YANKEE NUCLEAR POWER STATION

AMENDMENT TO FACILITY OPERATING LICENSE

Amendment No. 79
License No. DPR-3

ATTACHMENT TO LICENSE AMENDMENT NO. 79

Figure 3.2-1

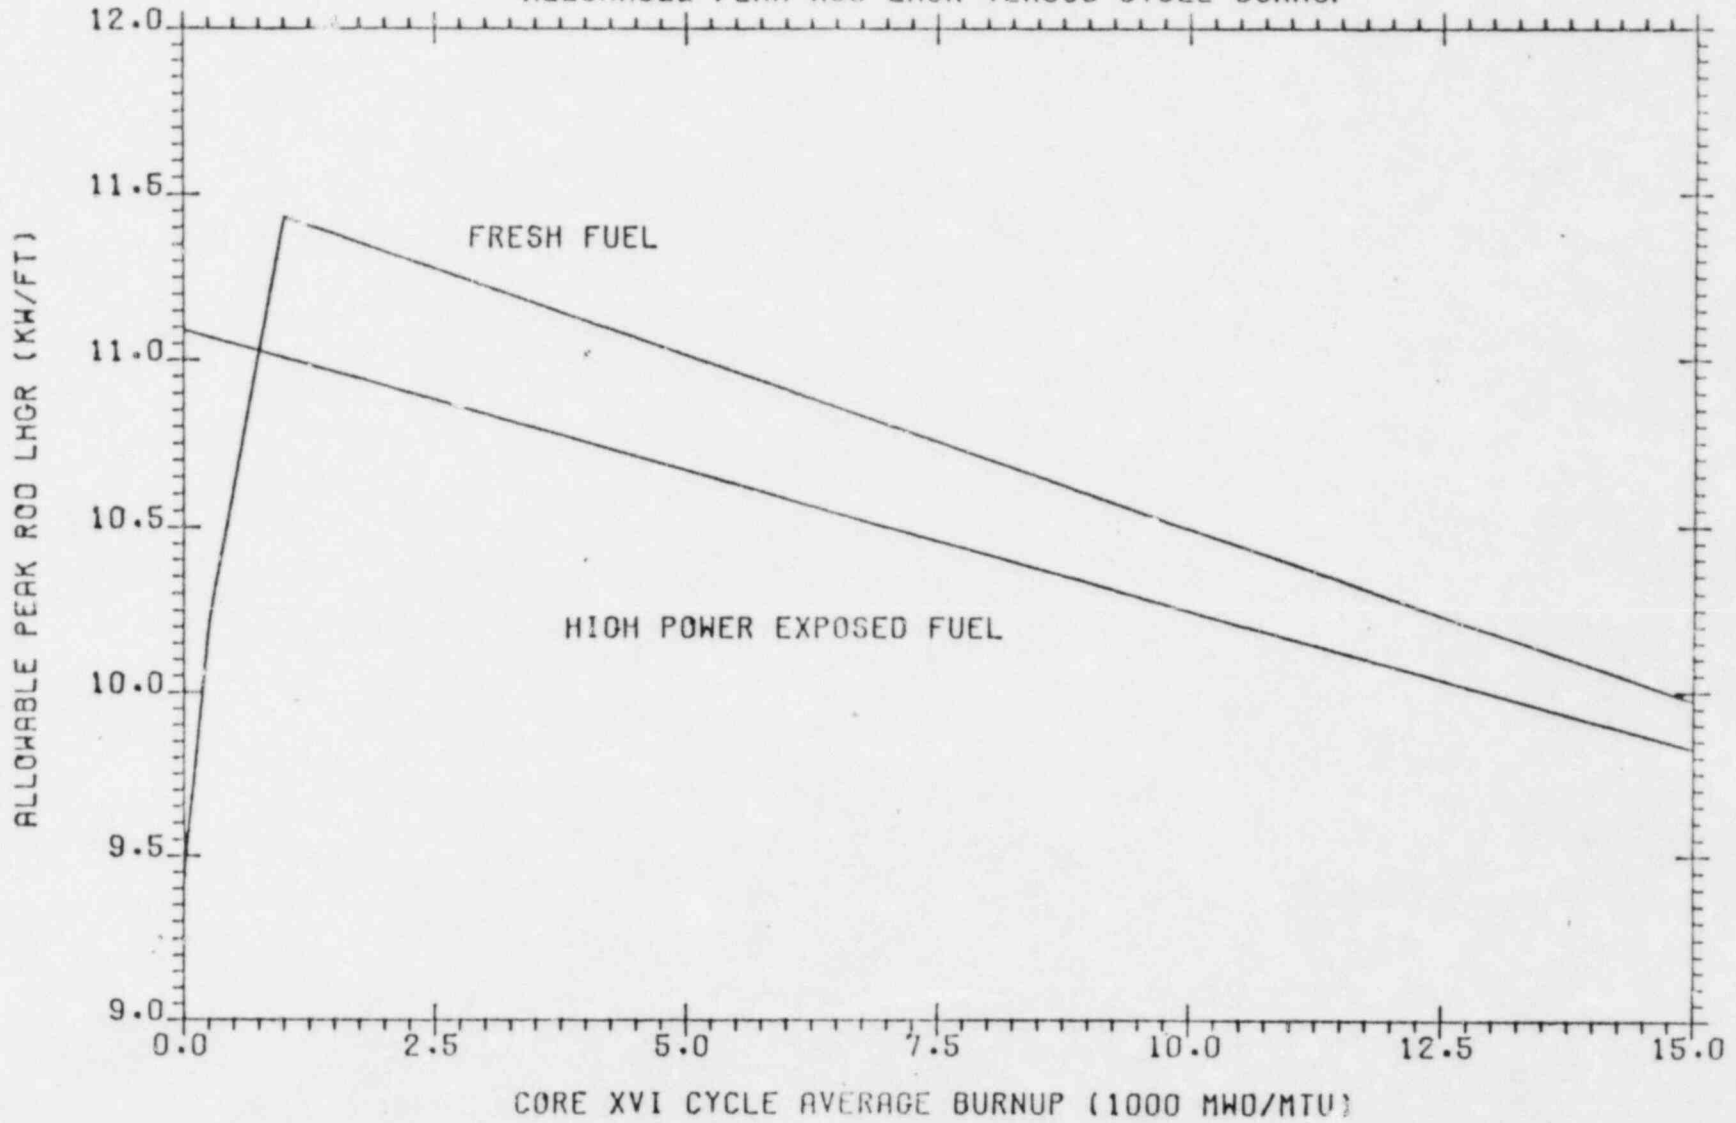
Replace the following page of the Appendix A Technical Specifications with the enclosed page as indicated. The revised page is identified by amendment number and contains a vertical line indicating the area of change.

YANKEE ROWE CORE XVI
ALLOWABLE PEAK ROD LHGR VERSUS CYCLE BURNUP
